REWORK INSTRUCTION

Product : CRT Monitor	Bulletin No. : 02-C/M-E0075-3
Model : GG15* (S/M 151S)	Bulletin Date : July. 20, 2002
	ECN Date : July. 20, 2002
SUBJECT : Display Extension Problem in PC Booting Stage (for World)

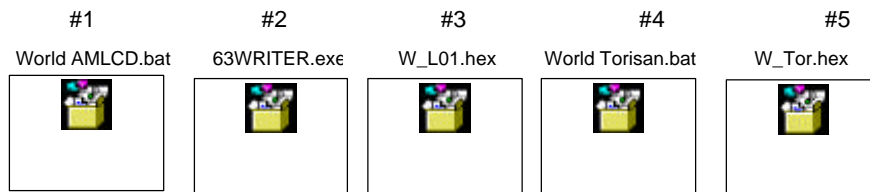
Defect Symptom **Display extension problem in PC booting stage.** If you have the monitor having this problem, sometimes you can see the phenomenon that the DOS display on booting stage is enlarged with a kind of waving noise. In this time, if you reset the monitor(turn off and on the power), the problem will be disappeared. This problem is caused by weak signal coming from video card or weak performance of scaler IC, we solve this problem by revising micom program.
